XNET SUB-PANEL BOARD

MICROCAST

2.1

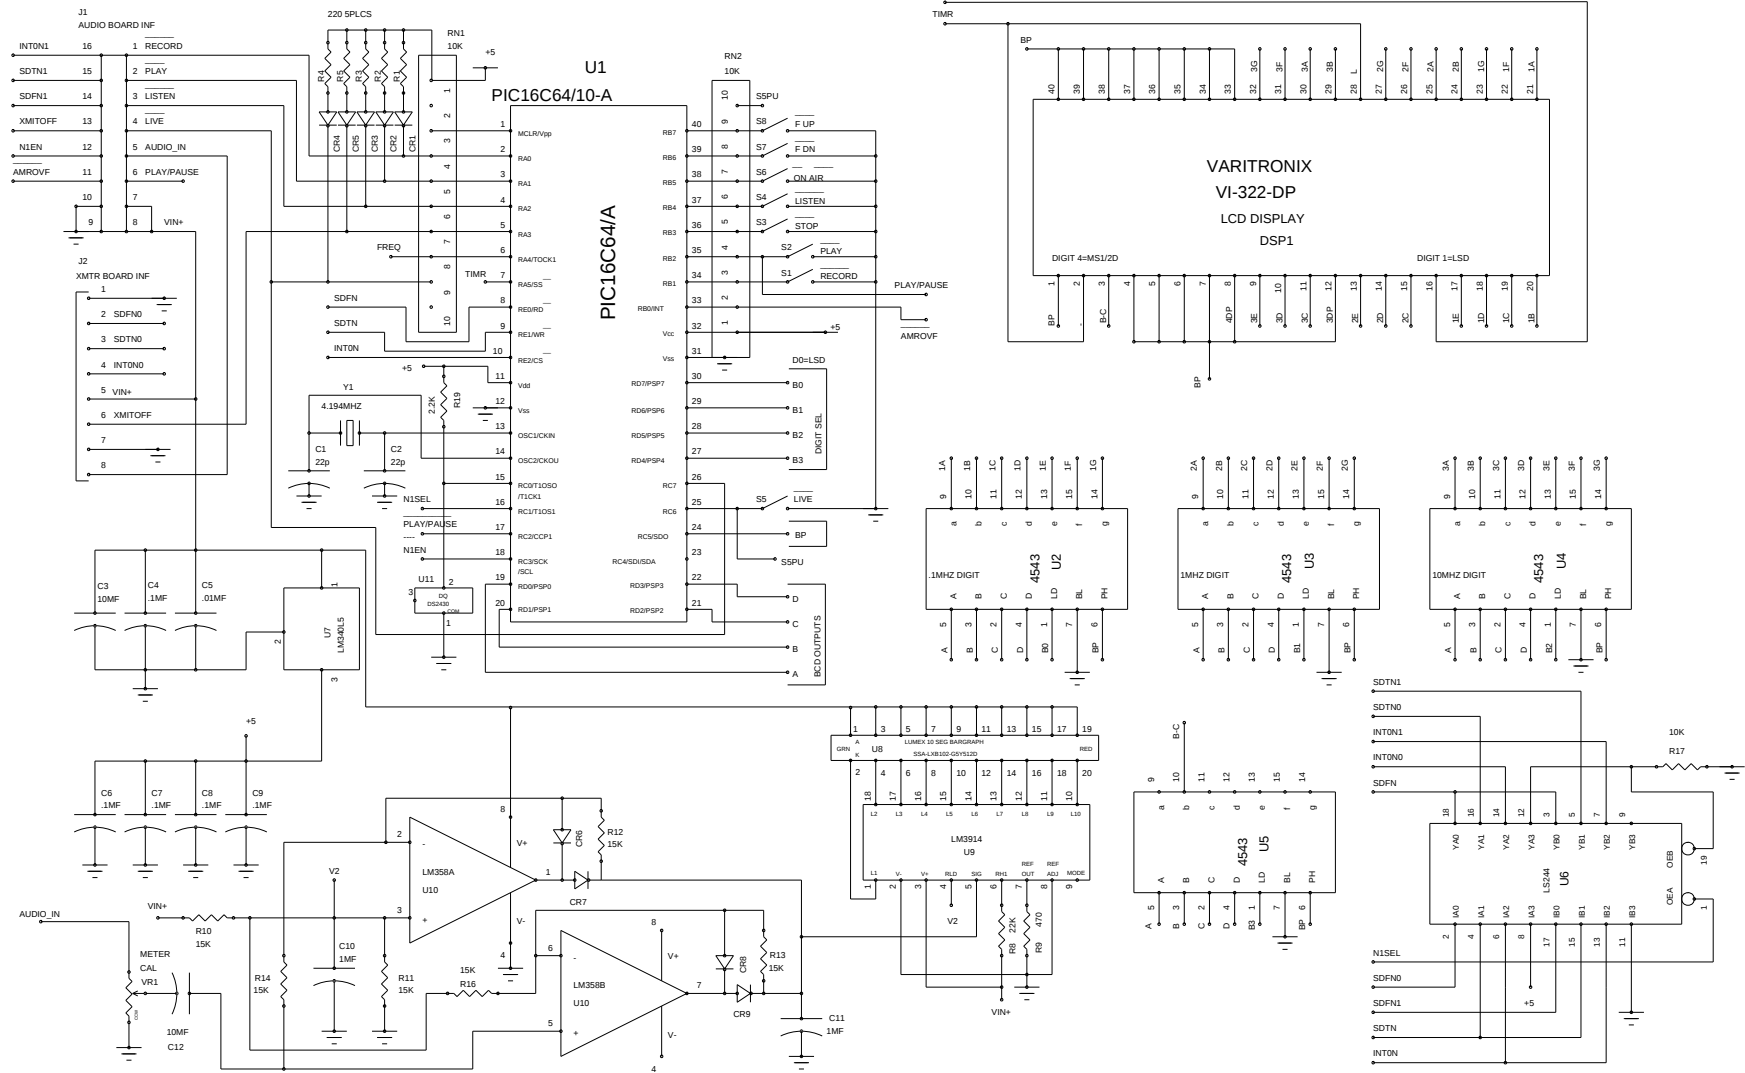
THE OLD U6 (4543) WAS DELETED. SOFTWARE REPLACED NEED FOR CHIP
THIS NEW VERSION ADDS TOTAL CONTROL OF 2 NOMADS.
ADDS PAUSE MODE TO THE MESSAGE REPEATER, AND CLEARS REC & PLAY
WHEN AN OVERFLOW OCCURS IN THE MESSAGE REPEATER.
